Item 7 - Correspondence

Re: MCPB Item 8
Bowie Mill Bikeway MR2023016 and Preliminary/Final Water Quality Plan

Re: Bowie Mill Bikeway# MR2023016 and Preliminary/Final Water Quality Plan

SC-14 ESC Plan

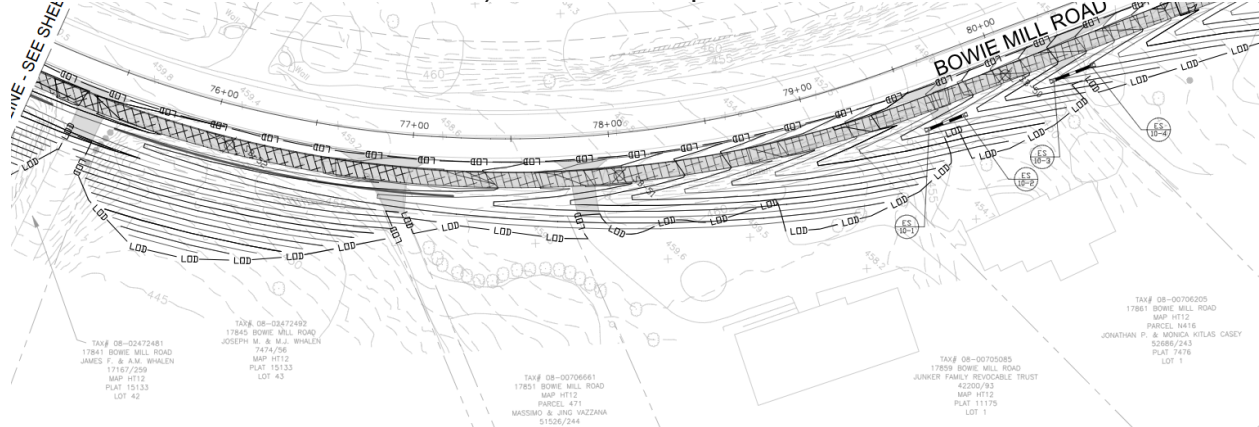
The impacts are hard to see since the regrading is not shown on any plans, other than an obsolete Sediment and Erosion Control Plan approved in January **2020**. At 60% design, why don't any of the plans on your DAIC site match?? Why hasn't MCDOT's website for this project been updated in years? Has the Board seen the

extent of the proposed grading?? If it looks anything like the old Erosion plan (that doesn't match the current MR set) here's a little peak:

Unfortunately, the Limits of Disturbance on the more recent Mandatory Referral plan looks like the impact may be even more vast.

I'm not asking for a massive retaining wall, and highway barriers that would greatly impact property values, but can't they grade in a way that doesn't impact residents as much? Not to mention, they plan to remove all of the mature trees on my property and the two properties to the east, some of the largest on the road. If the design and cross section is driven by the posted speed limit, then reduce the speed limit. Speed is a major issue on this road, which has led to numerous accidents, some resulting in death. Reducing the speed will actually make a difference and be consistent with the Montgomery County's Vision Zero initiative.

Figure 3: Typical Section outside of Special Protection Area

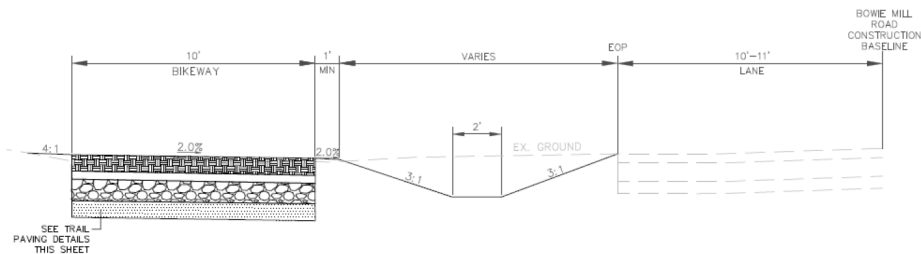
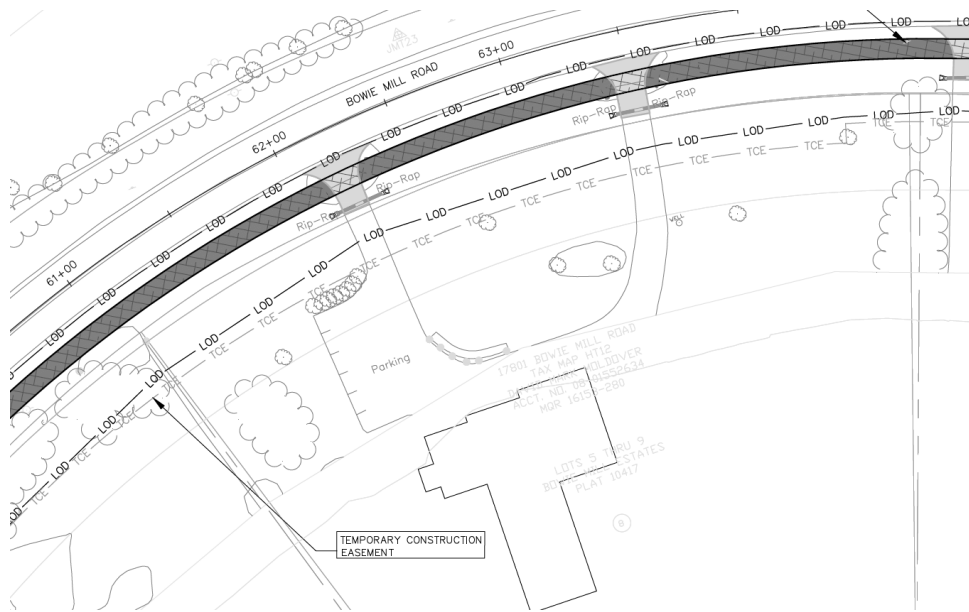
(1) Fig 3 from the staff report shows the bikeway being separated by a ditch, presumably the same ditch that is already there?:

However the schematic in Attachment A (our house on pg 10 is shown) shows the culverts/ditch between our house & the new path, can you please clarify whether the ditch will separate us from the path, or the path from the road?
